Planning Application P222769/F

Appendix

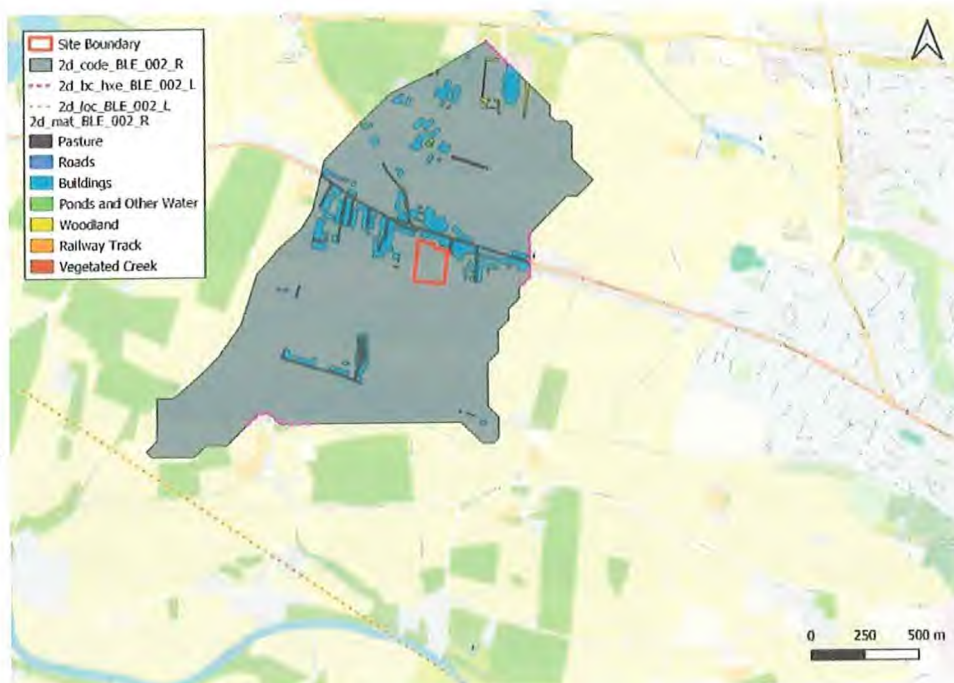
- a) Permeability of soils, with runoff less accurately predicted in highly permeable soils. The soils at the site within the catchment were described on Soilscales as “freely draining slightly acid loamy soils”. The entire catchment has an SPRHOST value of 38.04%, indicating a just below average permeability.
- b) Small drainage catchments can result in small rainfall depths. Runoff calculated by models with an initial storage component (such as the PDM model used in ReFH) may therefore be very sensitive to storage parameters and initial conditions. Total runoff estimates may therefore be uncertain.
- c) Urbanisation resulting in different surface characteristics and runoff coefficients to the natural catchment.”

However, much of the data used seems to have been obtained from maps, rather on-site observation and measurement, even when this accurate data was readily available.

I assume that the “freely draining slightly acid loamy soils” description applies only to the top soil and that the run off value is held constant at 38.04% throughout. If so, that implies that 61.96% of the rainfall soaks into the soils and continues to do so indefinitely. Does the input data specify that this soil is dry to begin with and of infinite depth and not subject to becoming waterlogged? The core samples taken on the site on 7th February 2023 show that the top soil is only 0.15m deep, below which is very impervious clay. The presence of this clay and the long periods of wet weather experienced in winter, suggests that some degree of waterlogging will be present before, and certainly during, most storm events. Does this water logging lead to an increased amount of surface water runoff? Does it also lead to a second source of run off through the soil itself along the top surface of the impervious clay, particularly on sloping ground which comprises most of the catchment? This theory is supported by Dr N Geeson's comments which identified a number of springs along the ridge which forms the southern end of the catchment. In that area, the underlying impervious surface is the Raglan Mudstone.

Sketch 1

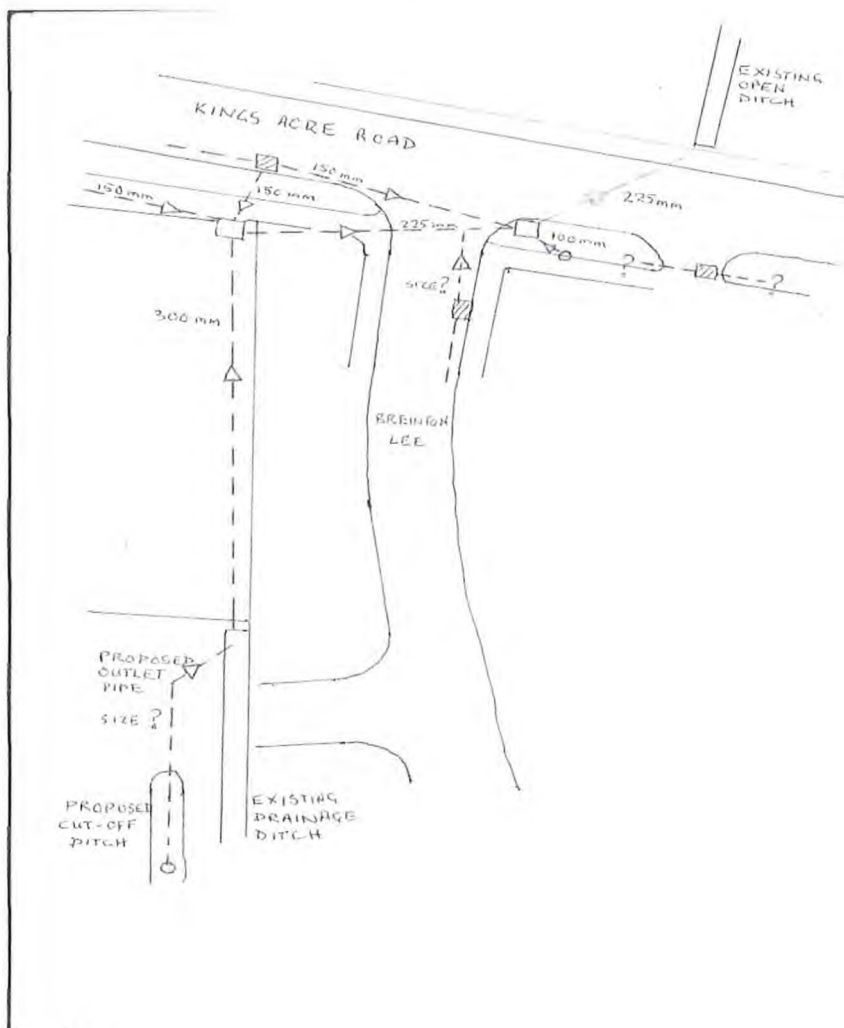
Also, if the ditch is indeed dry at the northern end, then there cannot be any flow from the ditch into the culvert under the garden of Number 343 and therefore no overflow from the open silt pit by the pavement on Kings Acre Road. However, as this overflow has in fact been observed and photographed on a number of occasions then the model must be wrong. As far as the flood risk on Kings Acre Road is concerned, the accurate modelling of these ditches is absolutely paramount and the apparent inaccuracy shown in the results suggest that the model is unreliable.

Also, of crucial and importance is the modelling of the drainage pipes under King's Acre Road. See Sketch 1 above. The survey carried out by Turnwater in 2013 shows that there is a 300 mm pipe running from the northern end of the ditch to the silt pit by the pavement on Kings acre Road. Part 1 of the survey said that this pipe is 225mm dia., but that survey was only concerned with surveying the pipes under Breinton Lee, whereas Part 2 was solely concerned with this pipe from the ditch, and it described it as 300mm dia., so I would take the latter as the more reliable figure.

The other inputs to this pit are two 150 mm diameter pipes carrying rainwater from the highway drains and the footpath drains. The outlet from the silt pit is a 225 mm pipe running east under Breinton Lee road to another pit, and then north on Kings Acre Road to discharge into an open ditch in the garden of number 304A Kings Acre Road. To make matters worse, there are two more inputs before the flow reaches the pipe under King's Acre Road. The Turnwater report mentions a pipe coming in from the side at 3 o'clock (from the south?) This is presumably from the road gully on the eastern side of the Breinton Lee roadway. There is also the 100 mm pipe from the footpath drain to the silt pit on the eastern side of Breinton Lee. Clearly, the capacity of the many input pipes exceeds that of the single output pipe, so when the capacity of the output pipe is exceeded, the excess overflows the open top of the first silt pit and floods along the footpath of Kings Road. As the gully in Breinton Lee is at about the same level (69.1m) it is also likely that this will overflow and flood the road surface of Breinton Lee. As the centre of Kings Acre Road is 300 mm above the level of the footpath, the floodwater cannot escape that way. Also, the drainage pipes from the roadway and the footpath feed back into the silt pit, so it cannot go that way either. The height of the top surface of the silt pit is very close to the height of the base of the drainage ditch (about 69.0m again). So, overflow from the silt pit will continue for as long as the ditch contains a significant depth of water. Clearly, flow rates in these pipes need to be accurately calculated to determine whether overflow from the silt pit will occur. There is no mention in the Note as to whether any flow rate constraints have been applied to the drainage pipes. This is another major cause for concern. It should be mentioned that the Turnwater survey of the pipes observed significant joint displacement which would reduce the theoretical capacity of the pipes and also likely lead to faster silt buildup, further reducing the capacity.

The situation will be exacerbated post development because the drawings show that the cut-off ditch will be connected to the existing ditch by an outfall pipe, thus increasing the flow in the 300 mm pipe running north to the open silt pit. Is this pipe included in the model? Also, the results show that post-development, the water level in the existing ditch will be increased, further increasing the likelihood that the open top silt pit will overflow.
